Cleveland City Planning Commission

March 20, 2026

Agenda: March 20, 2026

PROPOSED COLOR ELEVATIONS

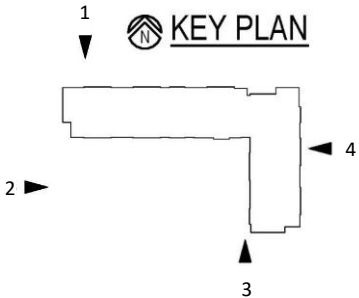
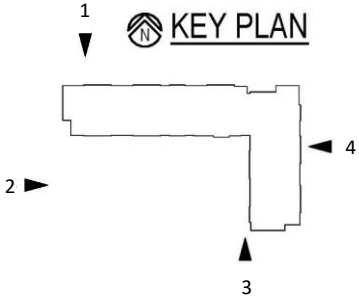
SIMPLIFY/ELIMINATE GABLES

-  UPDATED MASSING
-  REWORK CORNER MASSING . BRICK CLADDING, USE STOREFRONT GLAZING

SIMPLIFY/ELIMINATE GABLE

ENTRY ELEVATIONS

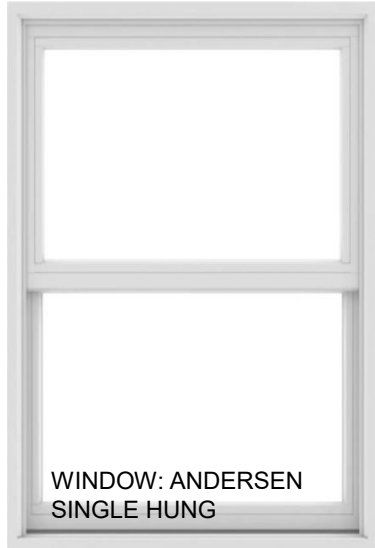
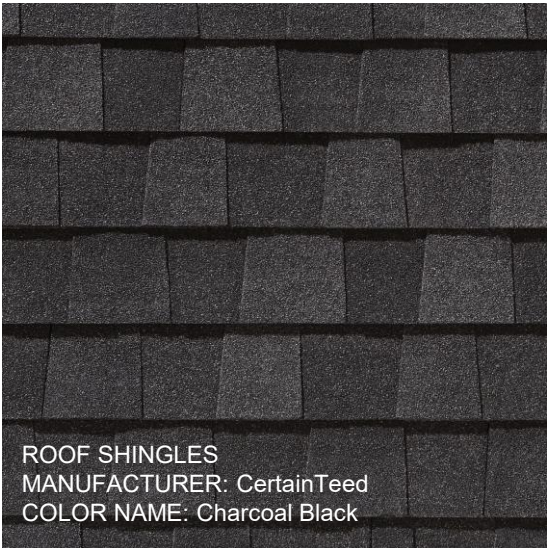
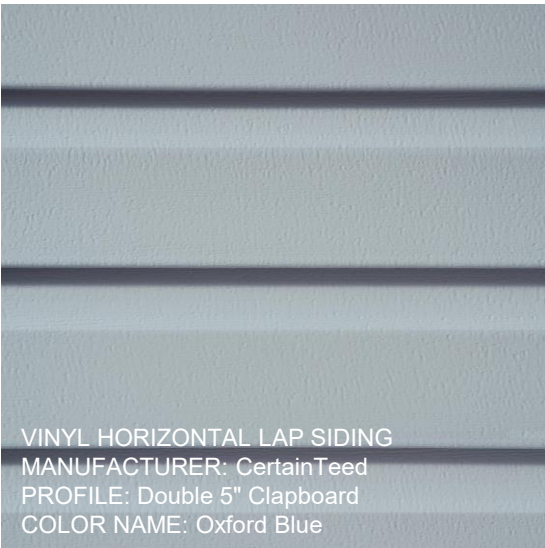
REWORK CORNER MASSING . BRICK
CLADDING, USE STOREFRONT GLAZING

SEDRAC recommended conceptual approval on 3/10/26 with the condition to study the architectural design of:

- How the building addresses the ground floor particular to the corner; the community space and building entrance
- Are there ways to simplify building mass and roof forms
- Accommodate storm water management into design (rear)
- Create a strong sense of place that is unique to neighborhood

EC2026-006 – Penn Square Pocket Park & Temporary Murals

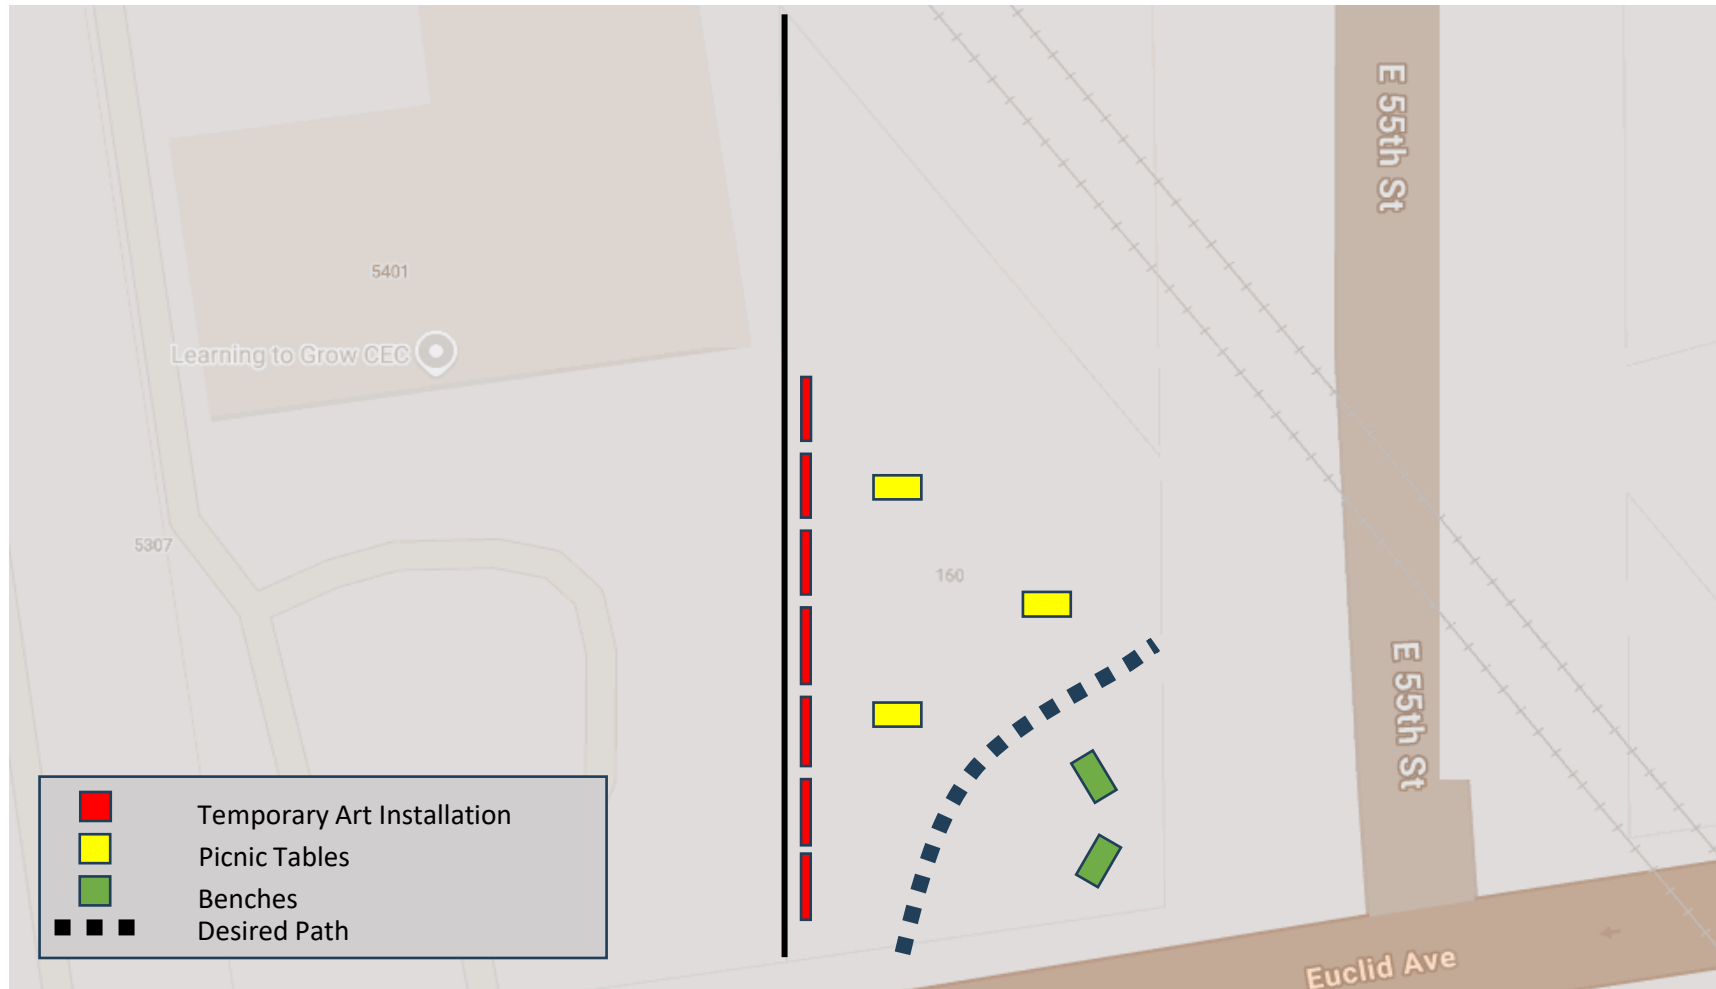
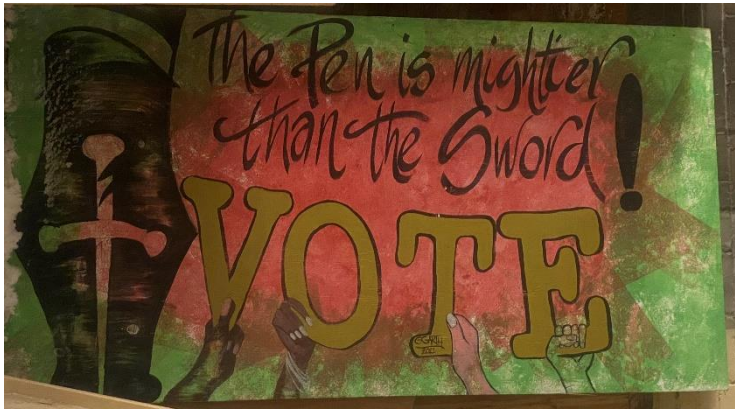
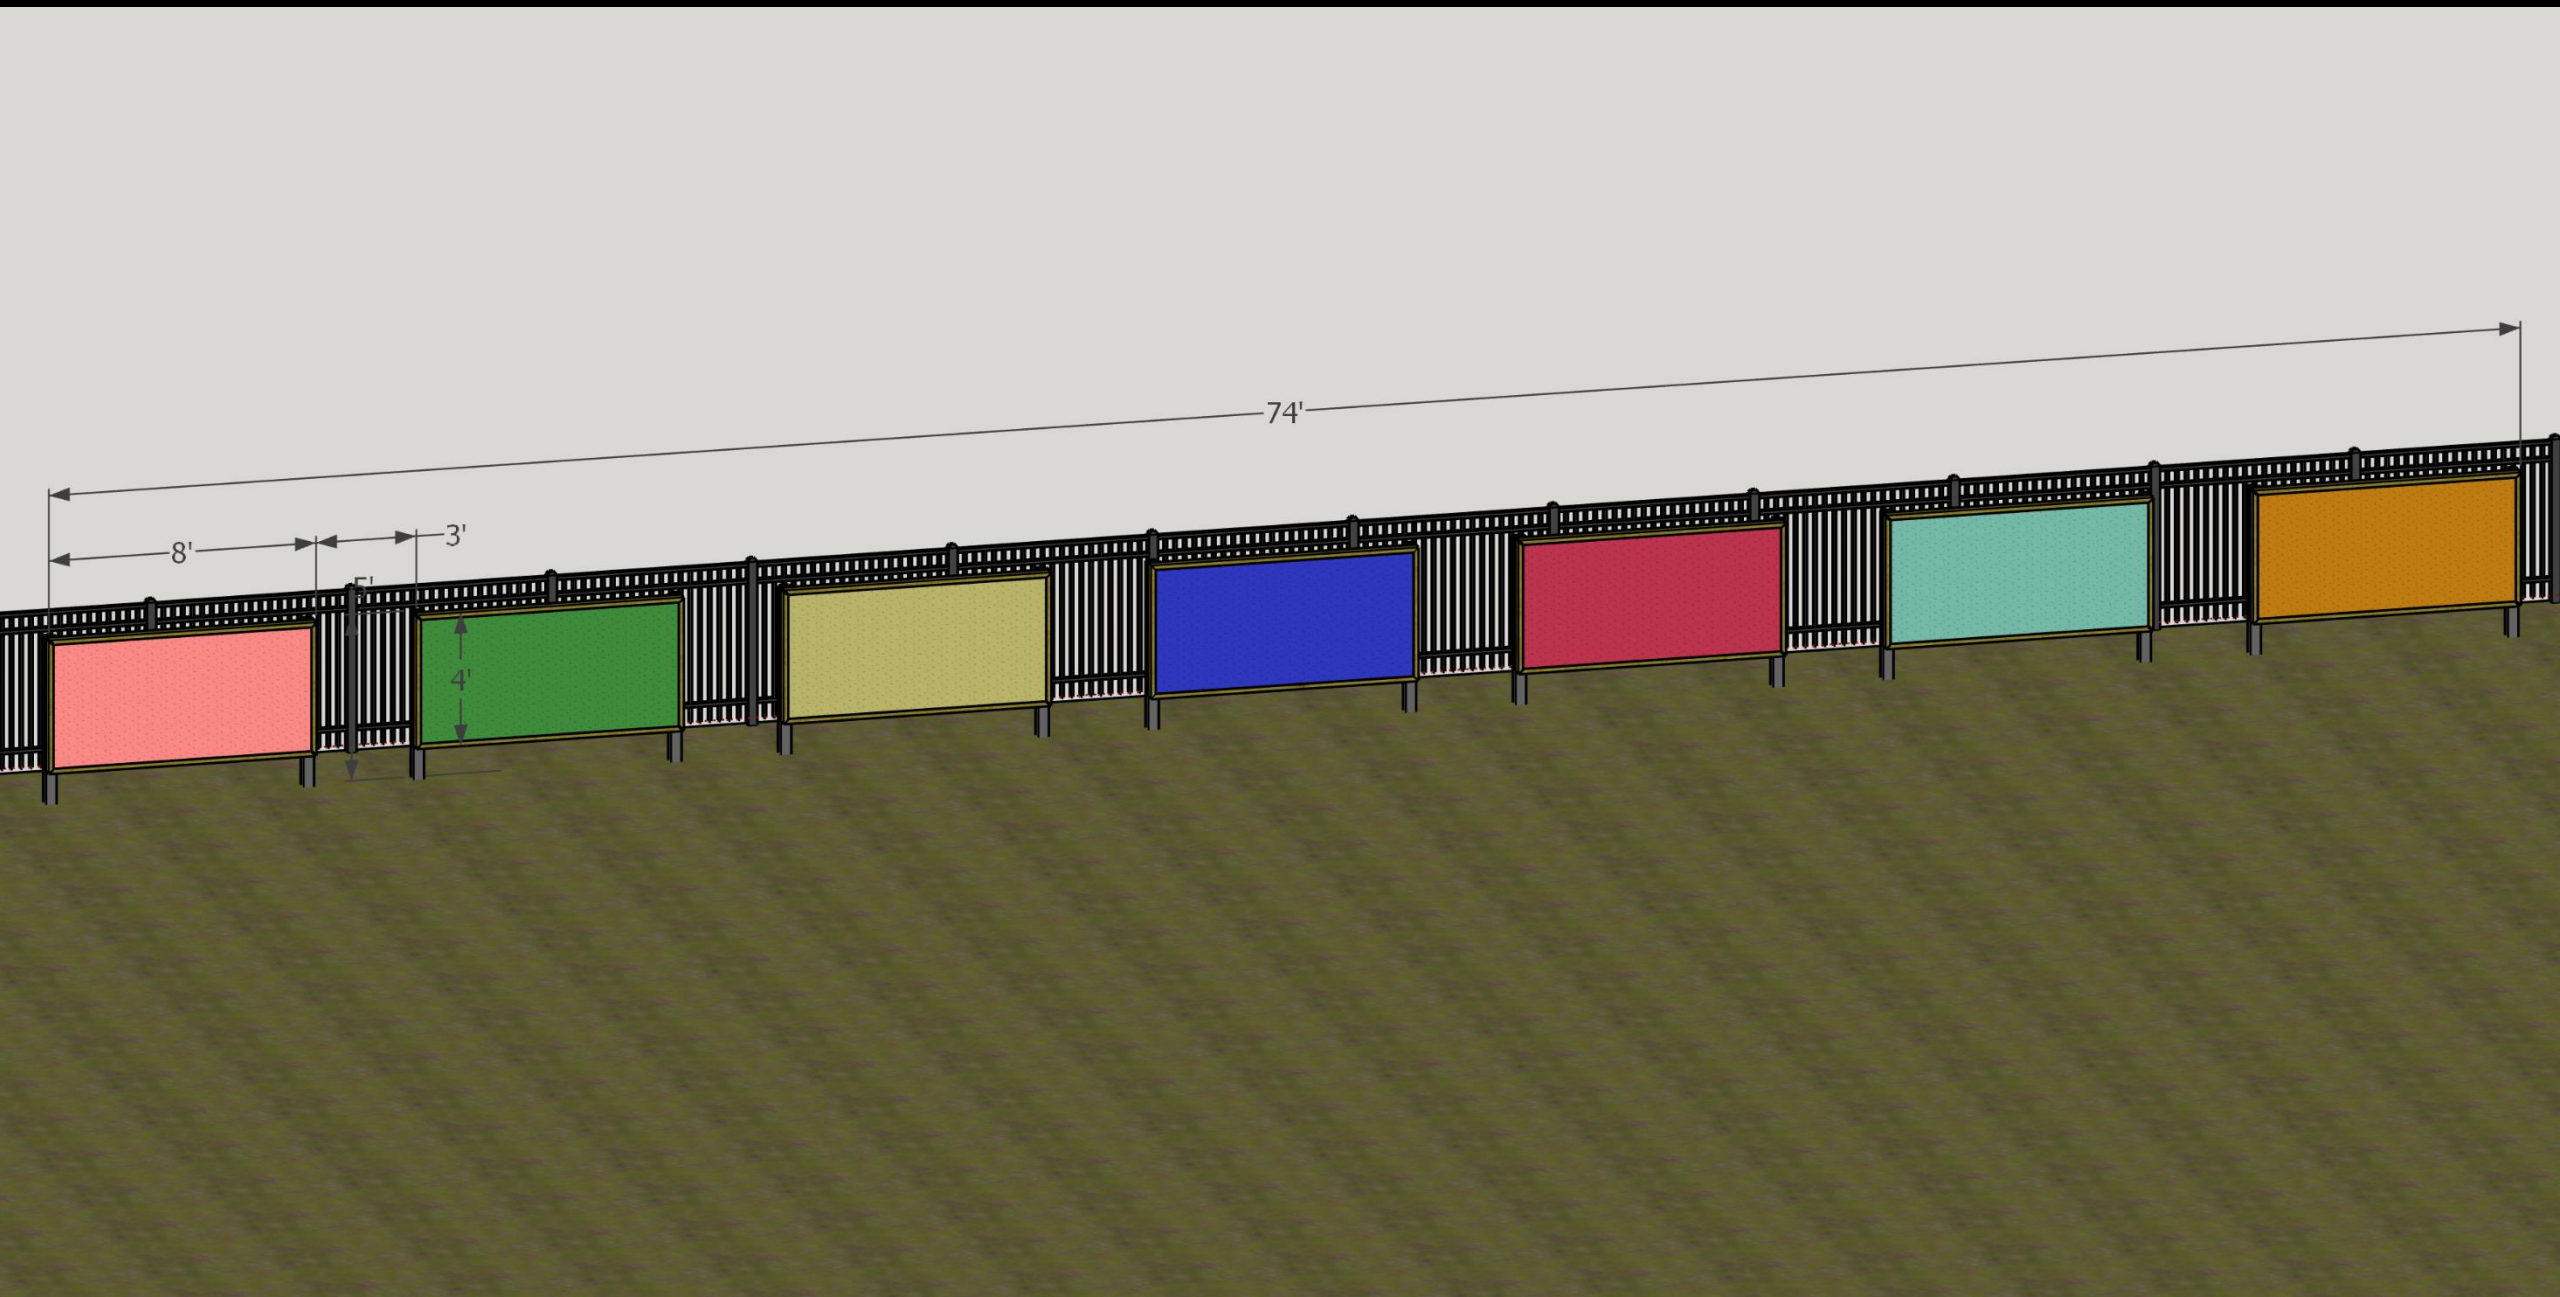
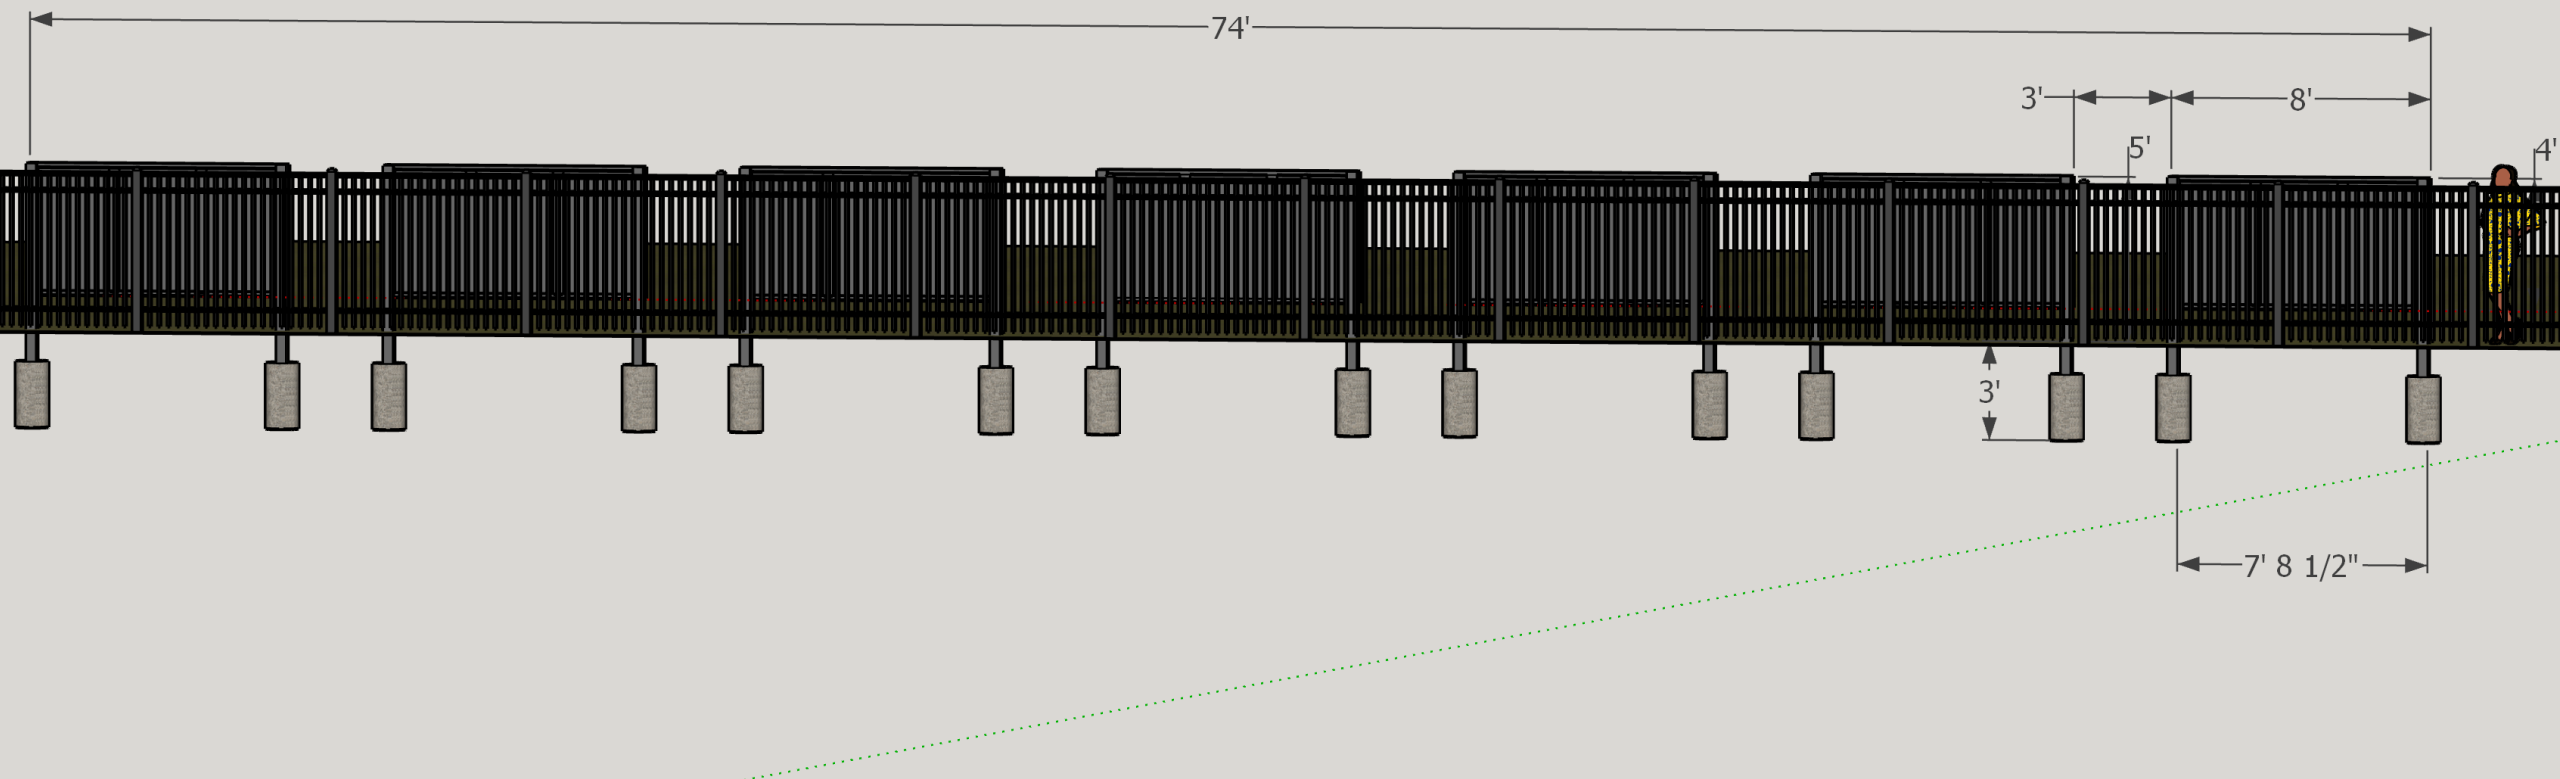
CEDRAC recommended final approval on 3/12/26 with the following conditions:

- Change color on back of mural panels to reduce contrast between fence and panels
- Space out panels to add visual permeability with potential to increase security
